Subject: Arkansas Nuclear One - Unit 2
Docket No. 50-368
License No. NPF-6
Environmental Qualification of
Foxboro and Rosemount Transmitters
(File: 2-1510)

Following our letters of September 15 and September 26, 1978, on the above subject, we received two verbal questions from the staff. These questions are repeated, as we understood them, and addressed below.

FIGURE 1

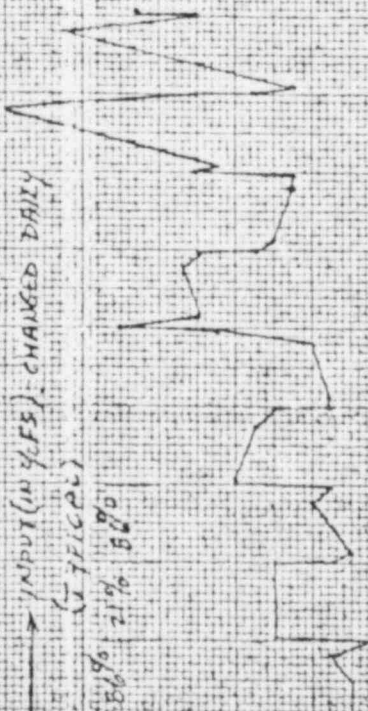
Our letter of September 26, 1978, indicated that we had experienced a problem with the Foxboro transmitter at 12 days into the LOCA test. At that time the Foxboro output went outside acceptance criteria and remained constant regardless of input voltage indicating a short creating enough resistance to negate the effect of the variable resistance created by the transmitter. Following removal from the LOCA chamber, the transmitter internals were replaced in an effort to restore the instrument output to acceptable levels. The replacement, however, failed to correct the problem as the instrument output still remained constant.

Following an investigation, wire insulation degradation and water was found inside the cable which ran from the instrument house, outside, to the LOCA chamber. This cable was supplied by the test facility and had been exposed to the environment (sun, rain, etc.) for quite some time. Upon replacement of this cable, the transmitter satisfactorily responded to the input signal.

We then replaced the old (tested) internals in the transmitter and it responded satisfactorily and within acceptance criteria. We therefore concluded that since the short was outside the test chamber and extraneous to the LOCA environment and since the instrument responded within acceptance criteria following the 30 day test, that it met the

requirements of our test procedure and is adequately qualified for use at ANO-2.

Table 1 and Figures 1 and 2 are the reduced test data, for both the Foxboro and Rosemount transmitters, through 12 days of the LOCA test.
